UNITED STATES PATENT AND TRADEMARK OFFICE

Office Action Summary

10/574,340

DETAILED ACTION

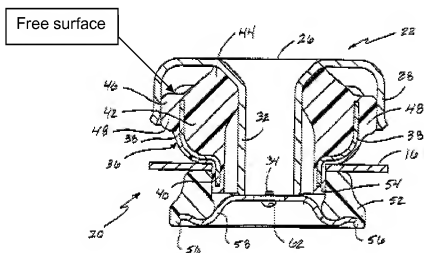
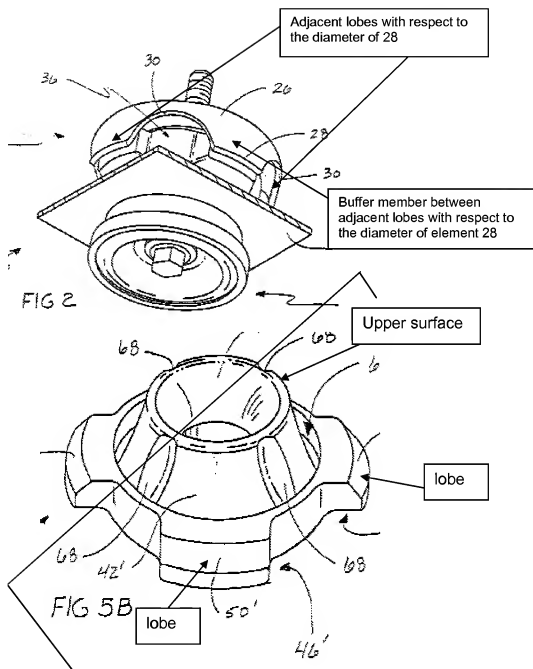
Re: claims 38-40. Rice et al. show in figures 1-3 and 4A a vibration mounting comprising a base member 16 for mounting to a mounting location and a support member 26 for supporting a load, the support member being spaced apart from the base member in a load-bearing direction by a vibration isolating element 36 of a resilient material, wherein the vibration isolating element comprises a plurality of lobes as labeled on pg. 6, 7 of this action each lobe extending from the base member towards

the support member, and buffer means comprising a first buffer or the contacting of the bottom of the top portion of element 28 with the top of element 38 for increasing resistance to displacement of the support member relative to the base member in the load-bearing direction beyond a positive displacement threshold and a second buffer or the contact of the top of element 58 with the bottom of element 40 for increasing resistance to a negative displacement beyond a negative displacement threshold.

Re: claims 19, 20, 27, and 28. Rice et al. show in figures 1-3 a vibration mounting comprising a base member 16 for mounting to a mounting location and a support member 26 for supporting a load, the vibration mounting having a centre-line in said load-bearing direction; wherein the support member is spaced apart from the base member in a load-bearing direction by a vibration isolating element of a resilient material, which comprises a plurality of lobes as labeled on pg. 6, 7 of the action in figure 5B on each side of a plane passing through said centre-line, wherein each lobe

extends outwardly from a central portion of the vibration isolating element secured to the base member towards the support member and also extends in a lateral direction different from that of other lobes, and wherein each lobe has an upper surface as labeled on pg. 6 engaging the support member and at least one free surface as labeled on pg. 6, 7

And wherein the vibration mounting comprises a buffer means including a buffer member shown at the end of the lead line of number 28 shown in figure 4A extending

from the support member towards the base member between adjacent lobes, particularly adjacent with respect to the diameter of element 28, of the vibration isolating element and a contact plate 38 affixed to a resilient material secured to the base member, wherein the buffer member contacts the contact plate when vibration displacements exceed a predetermined amplitude, and does not contact the contact plate when vibration displacements are less than the predetermined amplitude.

10. Applicant's arguments filed 2/3/09 have been fully considered but they are not persuasive. Applicant argues that Rice et al. fail to disclose a buffer member that is between adjacent lobes. Examiner disagrees and notes that on pg. 7 of the Office action Rice et al. illustrates a buffer member that is between adjacent lobes. Nothing in the claim language precludes adjacent lobes from meaning lobes situated across from each other as opposed to lobes situated circumferentially by each other. Applicant then argues that Rice et al. lack the limitation of the first and second buffer members, explaining that the cushions are always in contact with their rigid neighbors. Examiner disagrees and notes that the claim language simply requires buffer members or means and does not require that the buffer members or means comprise a gap between cushions as Applicant argues. The argument is more specific than the claim language. Examiner maintains that the limitation of increasing resistance to displacement beyond a displacement threshold is satisfied in Rice et al. by having multi-stage displacement/resistance as set forth in the rejections above similar to that of the instant invention except the gaps in Rice et al. are filled with elastomeric material. Accordingly, the rejections using the Rice et al. reference have been maintained.
